# Brookthorpe-with-Whaddon Parish Council

## Objections to Planning Application S.23/2428/OUT

### The Modal Hub Location and St. Margaret's Church

August 2018 - Taylor Wimpey Vision for Whaddon

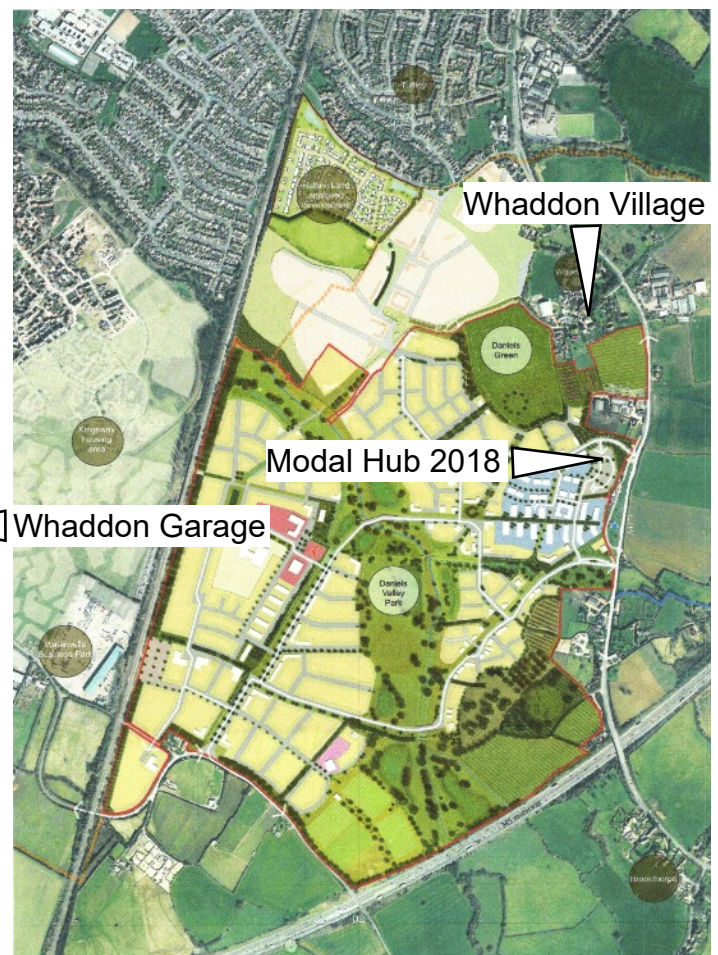
This shows the Modal Hub to the rear of Whaddon Garage with two entrances onto Stroud Road.
